# ***Proposed changes to Clause 3***

**Kevin Daines**  
**World Wide Packets**

**30 September 2004**

**NEW** Figure 3-1  
MAC frame format

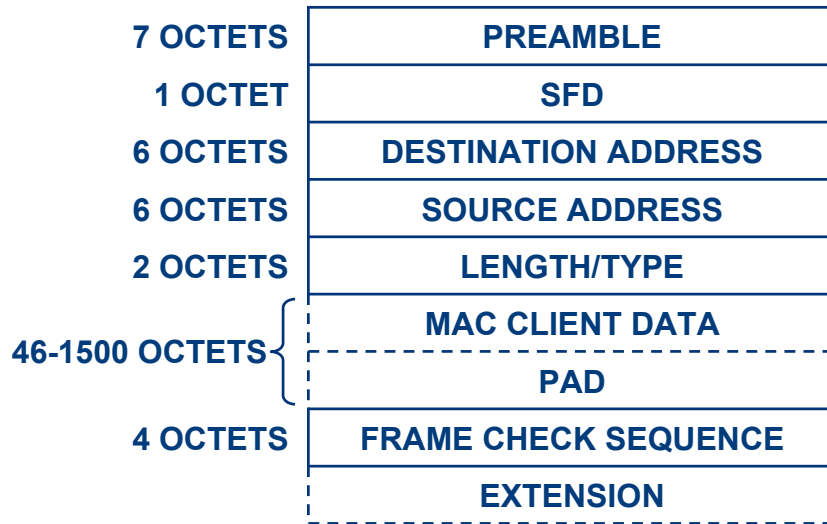
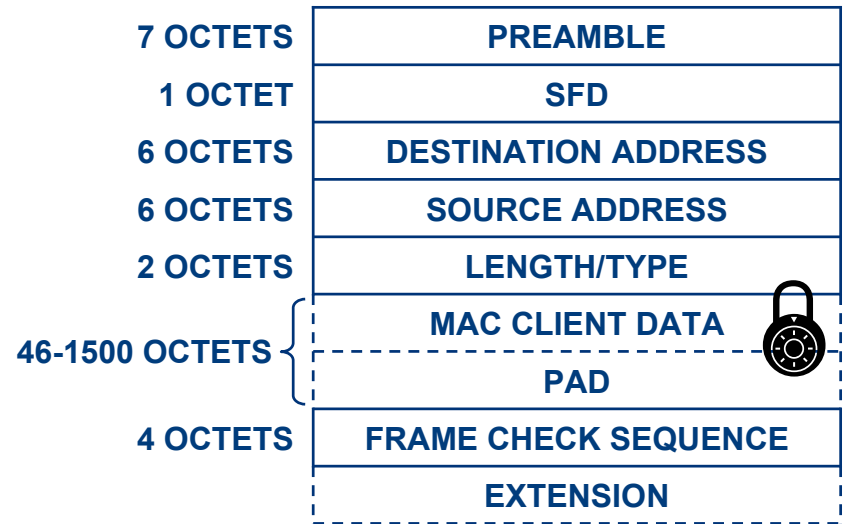
Current Figure 3-1  
MAC frame format

**NEW** Figure 3-3  
Envelope MAC frame format

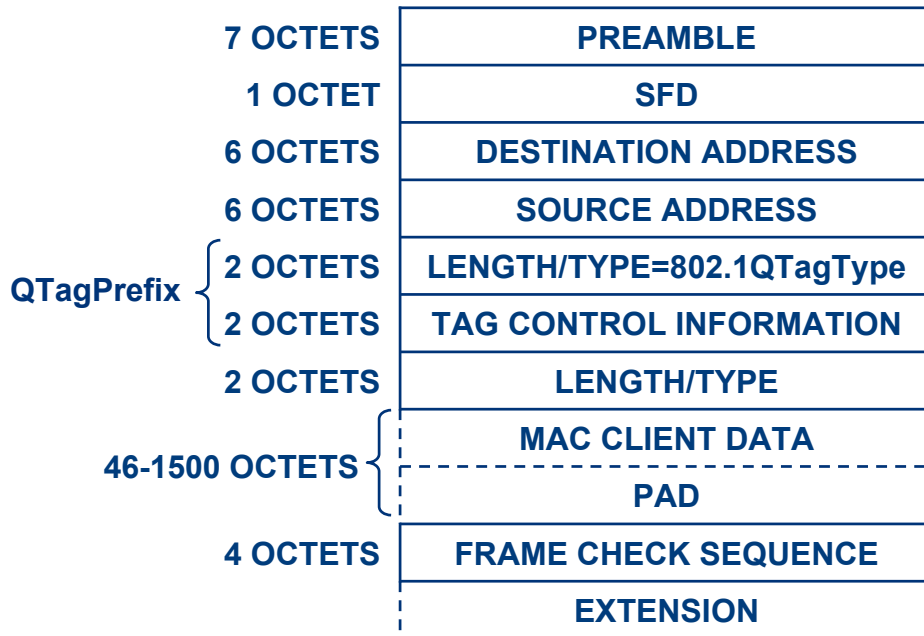
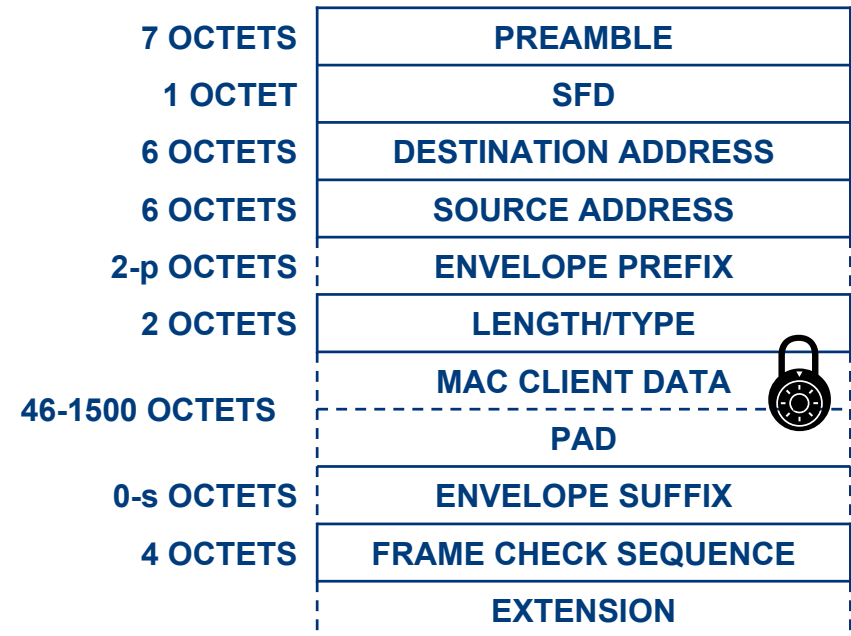
Current Figure 3-3  
Tagged MAC frame format

p is 2 to max[2, TBD – suffixSize]

s is 0 to max[0, TBD – prefixSize]

- **Proposed Figure 3-3 provides flexible means to upper layer protocols to convey additional fields, both before and after the payload**

# Frame sizes

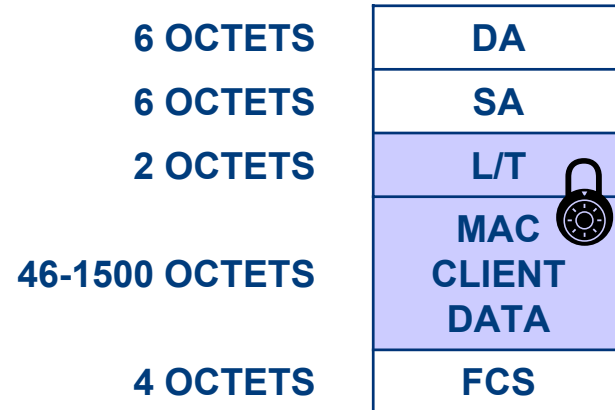
Frame Sizes (octets)	802.3-2002	NEW
Minimum basic MAC frame size	64	64
Maximum basic MAC frame size	1518	1518
Minimum Tagged MAC frame size	64	N/A
Maximum Tagged MAC frame size	1522	N/A
Minimum <i>Envelope</i> MAC frame size	N/A	68
Maximum <i>Envelope</i> MAC frame size	N/A	TBD
